Product Change Notification / CENO-05PDXJ039

Notification Subject:

CCB 6234 Final Notice: Qualification of 90x90 mils and 95x155 mils lead frame paddle size for AT93C56A-10SQ-2.7-T, AT88SC1608-10SU-00, AT88SC1608-10SU-00-T, AT17LV256-10NU and AT17LV256-10NU-T catalog part numbers (CPN) available in 8L SOIC (3.90mm(.150in)) package at ANAP assembly site.

LEAD FRAME COMPARISON

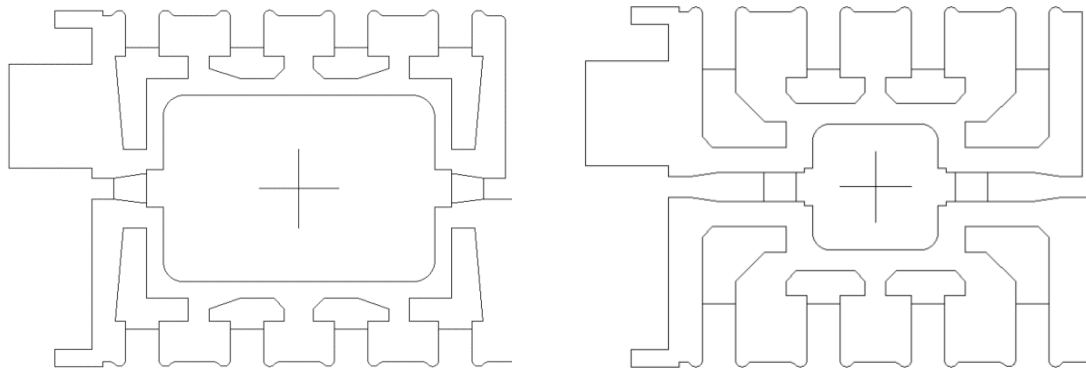
ANAP

90 x 130 mils

60 x 60 mils

Lead frame Material	C194	
Lead-Frame Paddle Size	90 x 130 mils	60 x 60 mils

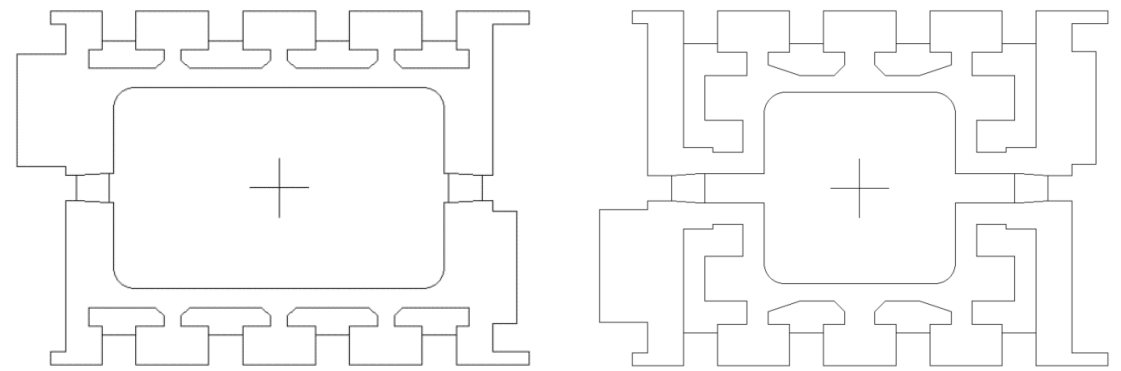
ANAP

95 x 155 mils

90 x 90 mils

Lead frame Material	C194	
Lead-Frame Paddle Size	95 x 155 mils	90 x 90 mils
